Docket Item # 6  
BAR CASE # 2008-0162

BAR Meeting  
October 15, 2008

Figure 3: Proposed demolition

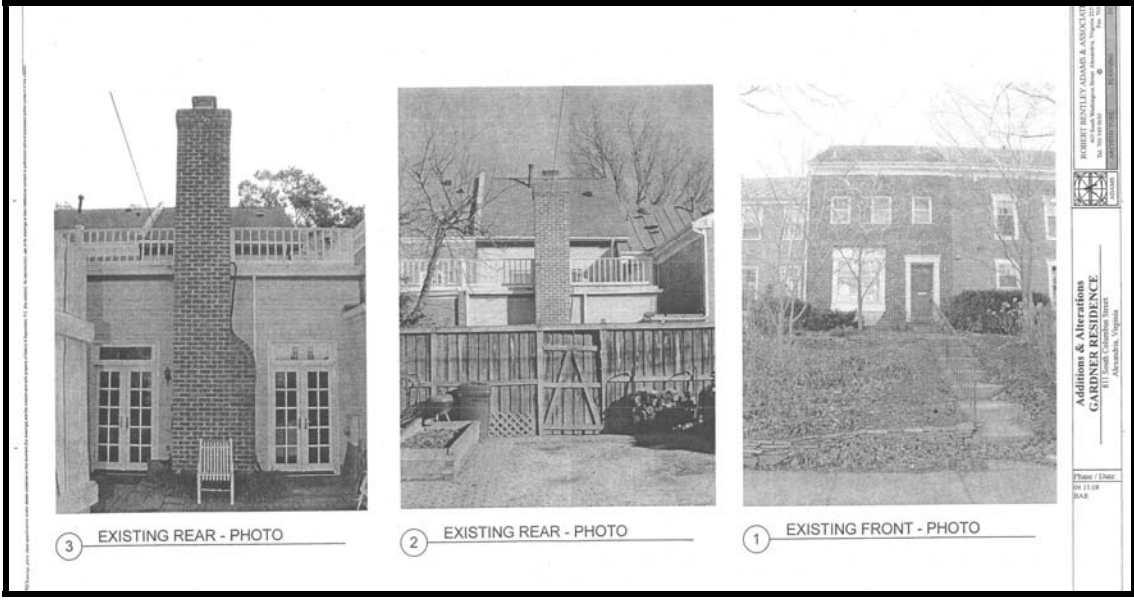
The applicant is requesting approval of a Permit to Demolish/Encapsulate in order to construct a new second story addition at 811 South Columbus Street. Portions of the existing second floor rear wall and windows, as well as the railing of the existing second story rear deck, will be demolished. The new addition will be constructed over an existing one story addition and will include a well for two HVAC units. The addition will measure 18' wide by 19.8' deep and will have a gable roof with asphalt shingles. The existing chimney will be raised approximately 8' to accommodate the height of the second story addition.

In the opinion of Staff, none of the above criteria are met. The proposed demolition/encapsulation is minimal in scale and confined to the second story of the rear elevation. Furthermore, the majority of the townhouses in this row already have two story additions, which were constructed during the 1970s renovation.

Staff recommends approval of the Permit to Demolish/Encapsulate as submitted.
